CRYSTAL RIVER UNIT 3 NUCLEAR GENERATING PLANT

AMENDMENT TO FACILITY OPERATING LICENSE

Amendment No. 56  
License No. DPR-72

ATTACHMENT TO LICENSE AMENDMENT NO. 56

FIGURE 2.1-2  
 REACTOR CORE SAFETY LIMIT

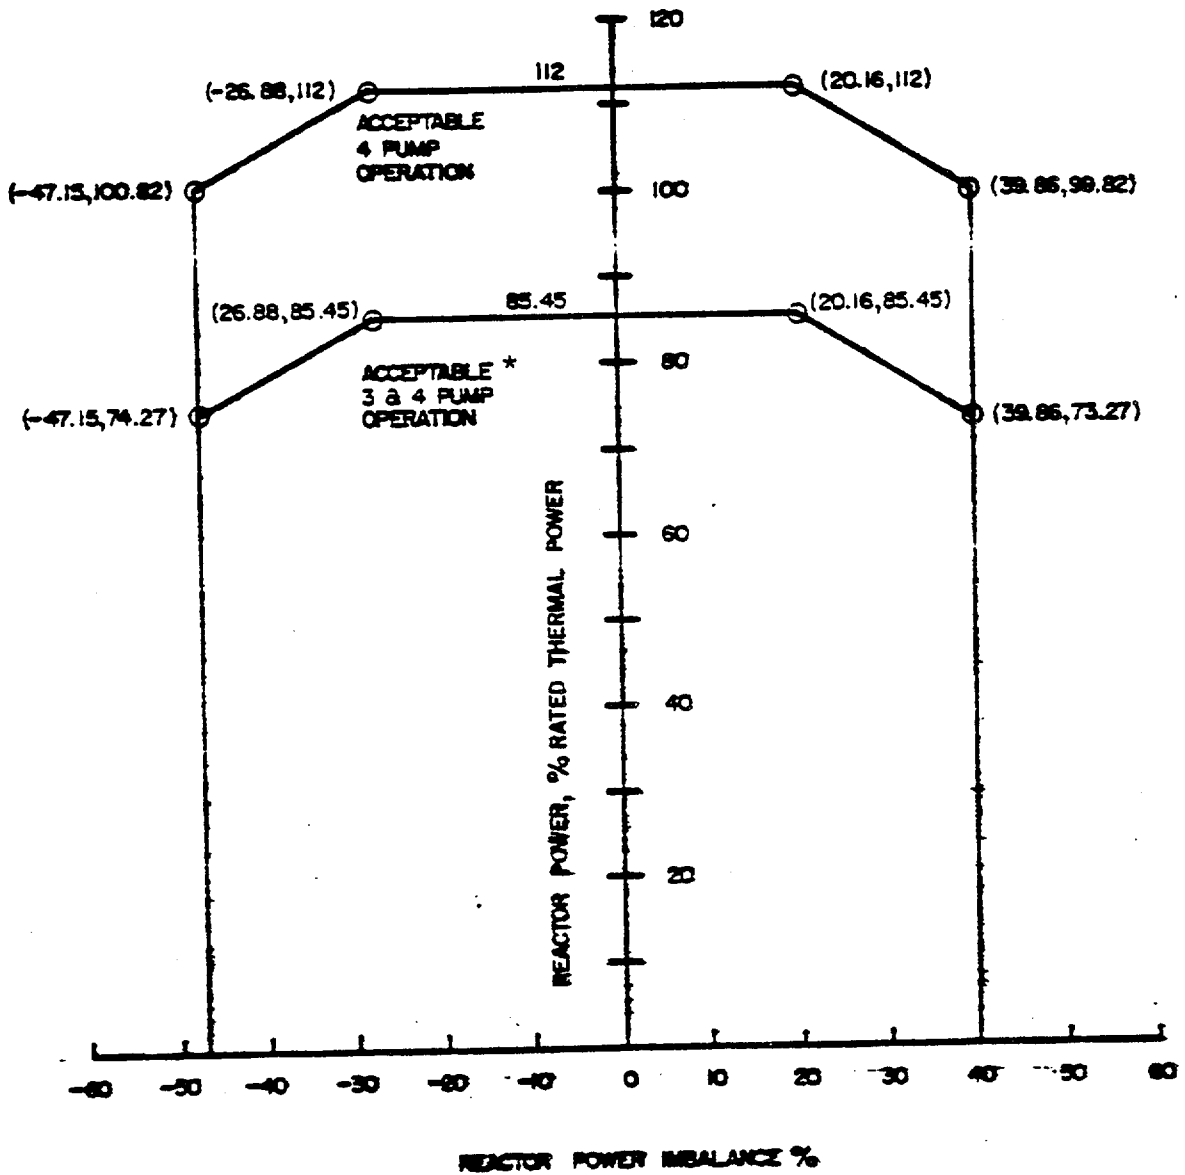
\*Operation with three reactor coolant pumps with RCCPMs bypassed is not permitted.

FIGURE 2.2-1

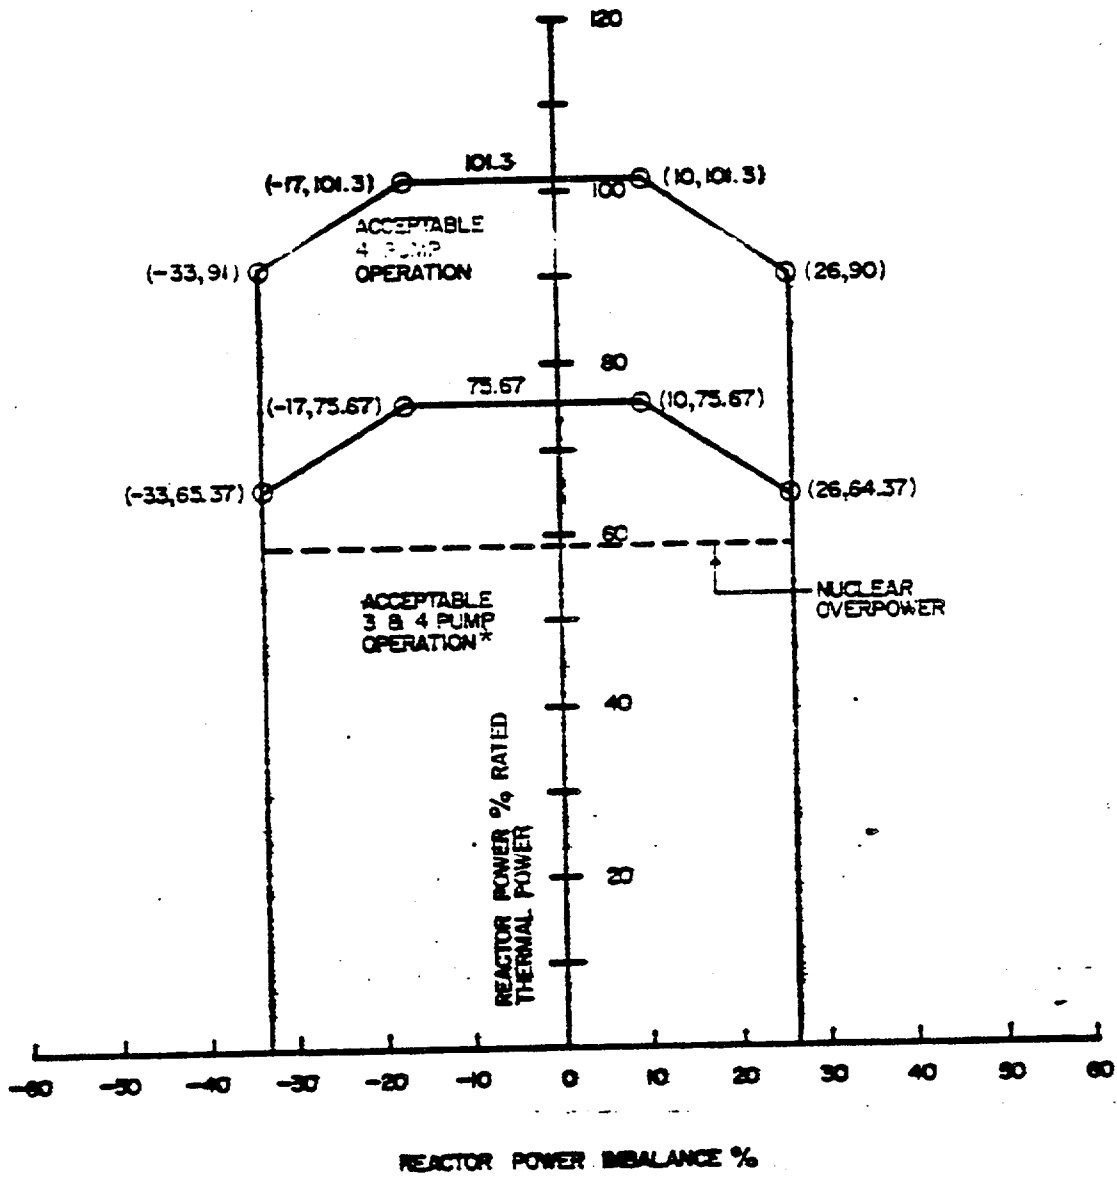
\*Operation with three reactor coolant pumps with RCPs bypassed is not permitted.
